Report of the Head of Development Management and Building Control Committee Report – Application Report

6039/APP/2024/3226

Site Address: **18 St Catherines Road, Ruislip**

Proposal: **Variation of Condition 2 (Accordance with Approved Plans), Conditions 3 (Tree Protection) and 5 (Landscaping) of planning permission ref. 6039/APP/2021/3465 dated 03.03.2022 (Removal of derelict scout hut and storage unit to facilitate the erection of a replacement single storey scout hut building). The minor material amendments include changes to accessibility (with external ramp and disabled parking), hard and soft landscaping and external fittings; minor change to the building's overall positioning on the site; and fenestration changes on front elevation plan with repositioning of fire exit door.**

Figure 4: Proposed Plan (please note – larger version of plan can be found in the Committee Plan Pack)

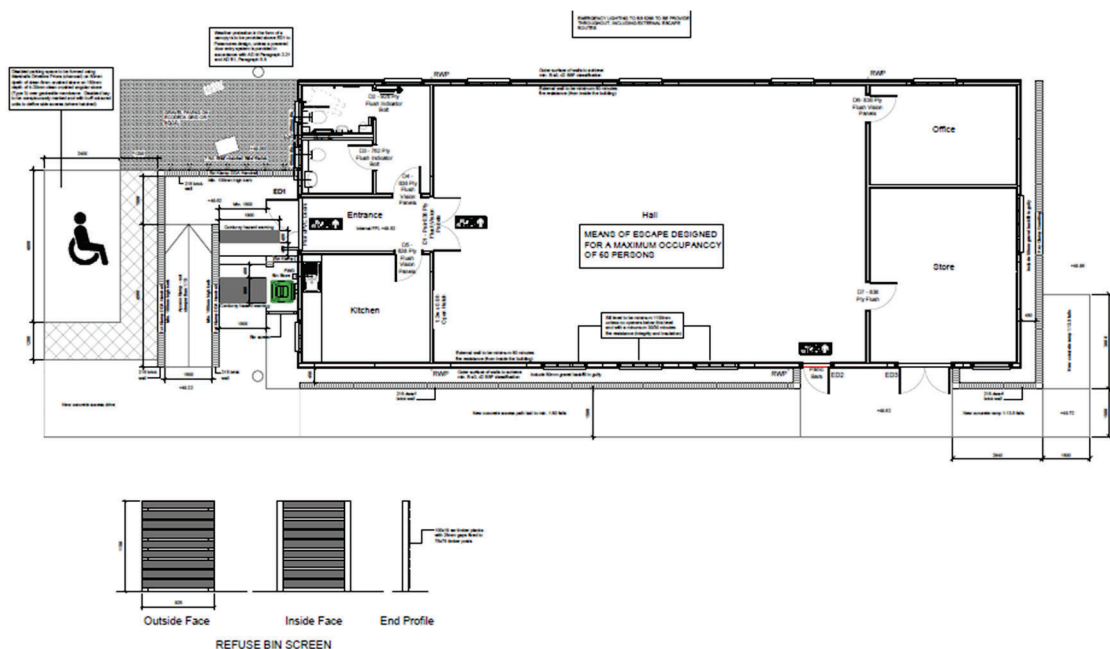
- 3.3 Inclusive access arrangements are now included in the variation of the permission. A ramped entrance measuring 1.5m wide would provide access for all. This ramp would have a brick support structure with a DDS handrail system (maximum height 1.3m). In front of the proposed ramp, there would be onsite disabled parking. Internally, the scout hut would now include a wheelchair accessible toilet.

- 3.5 During the course the assessment, it was also noted a minor positioning change of the building itself. To the front towards the southern boundary with No. 16 St Catherines Road, the edge of the building was originally 3.727m away from this neighbour's boundary. This would be reduced to 3.027m. As the building would be brought closer to the boundary, a second period of consultation has been undertaken.

Figure 5: Proposed Site Layout Plan (please note – larger version of plan can be found in the Committee Plan Pack)

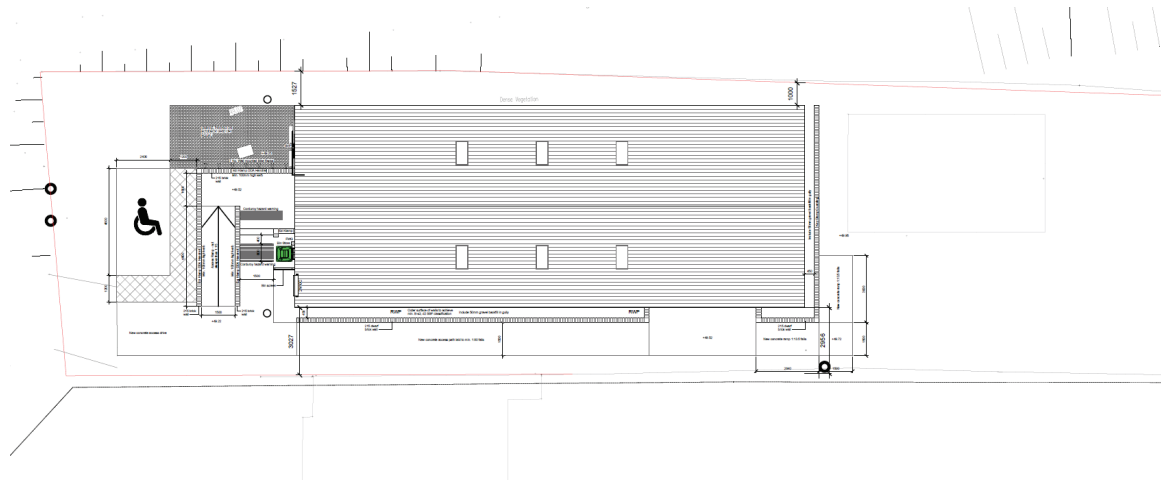
- 3.4 The layout plan incorporates hard and soft landscaping changes which have been included within a previous details application and include a dwarf wall and access path alongside providing an access route from the emergency exit door.

- 7.14 Under the original approved application, the site included two car parking spaces onsite and the bin store over on the southern boundary. One of the car parking spaces would be sacrificed to accommodate the proposed disabled parking space and new access ramp. The bin store is also proposed to be repositioned closer to the building with a gravel paving area situated towards the northern side of the building. Whilst limited soft landscaping was secured, the existing trees along the site boundary were protected. This ensures that the site would continue to have a leafy appearance along the street. The proposed re-siting of the fire exit door on the elevation would have a negligible impact.

Figure 6: Proposed Elevations (please note – larger version of plan can be found in the Committee Plan Pack)

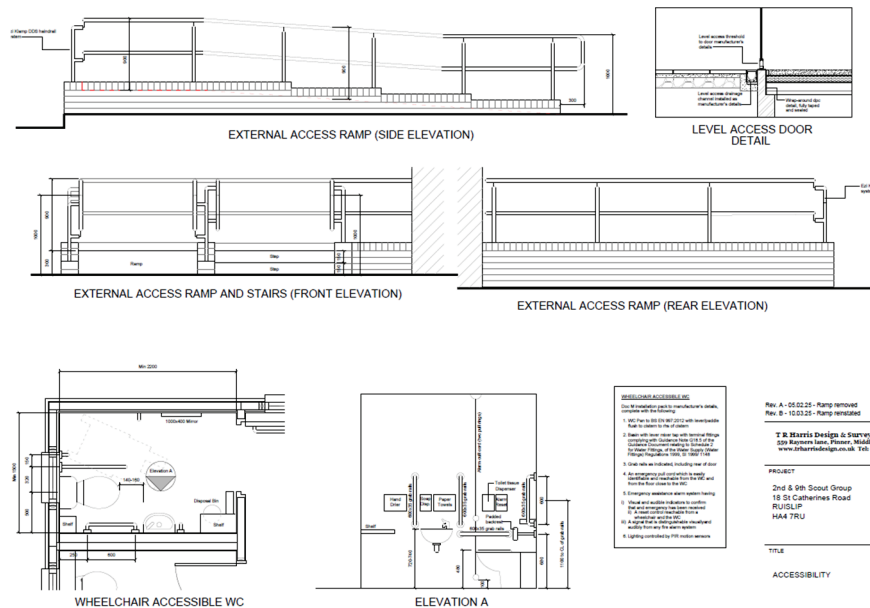
- 7.10 The proposed ramp would be situated to the front of the building extending approximately 6.2m along this elevation. It would have a projection of approximately 4.5 metres out from the front wall which provides sufficient space for a ramp and external step. Whilst the new access arrangement would be partially visible from the street scene, it would remain modest in overall height. It is worth pointing out that the site is also largely screened by the existing vegetation to the front. The building and proposed ramp would also be set back a sufficient distance from the street to not cause any significant visual impact on the wider local character.

- 7.11 Furthermore, the proposed accessibility arrangement would generally visually blend into the larger building within the background. In general, the materials would be acceptable with brick and safety rails sympathetic to the main building. Additionally, the ramp would provide public benefits by improving accessibility.

Figure 8: Shows original parking approved 6039/APP/2021/3465 on the left and the revised parking under current S73 on the right (please note both plans are different scales 1:200 and 1:100 respectfully).

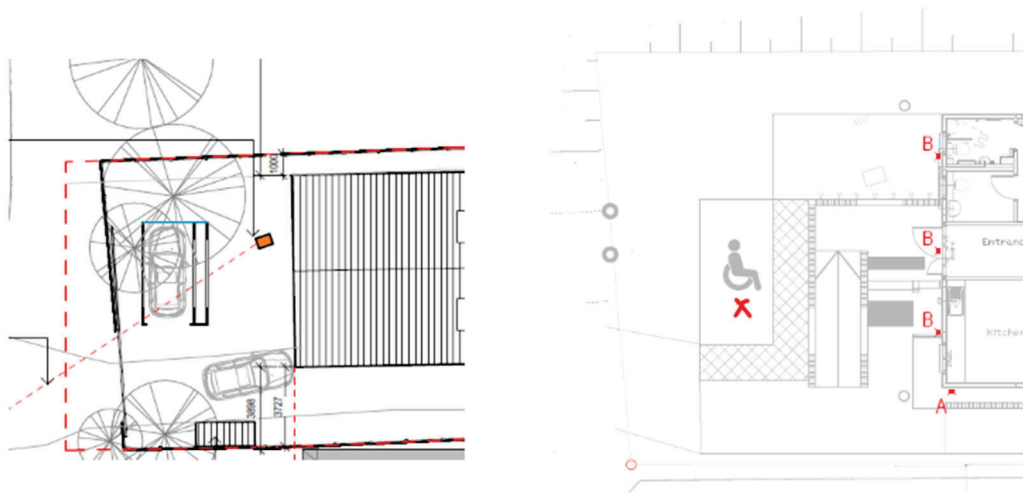
- 7.29 The key change under the current s73 application in highways terms is the alteration of the parking to provide a disabled parking bay. Figure 8 below shows the original approved parking on the left-hand side and the revised parking submitted under the current s73 application on the right-hand side with the parking marked with a red x. Onsite parking originally approved showed space for 2 onsite vehicles. With the inclusion of a fully compliant disabled parking bay, this would be reduced to 1 onsite parking bay.

- 7.30 The Highways Officer has been consulted on this amendment and is satisfied that the scheme would not lead to any highway safety or car parking pressures. Given the provision of a suitably located disabled compliant parking bay, it would also ensure that there is an onsite parking bay for disabled persons which is welcomed.
- 7.31 The application has been reviewed by the Highways Authority who are satisfied that the proposal would not discernibly exacerbate congestion or parking stress, and would not raise any measurable highway safety concerns, in accordance with Local Plan: Part 2 Development Plan Policies DMT 1, DMT 2 and DMT 6 and Policies T4 and T6 of the London Plan (2021).
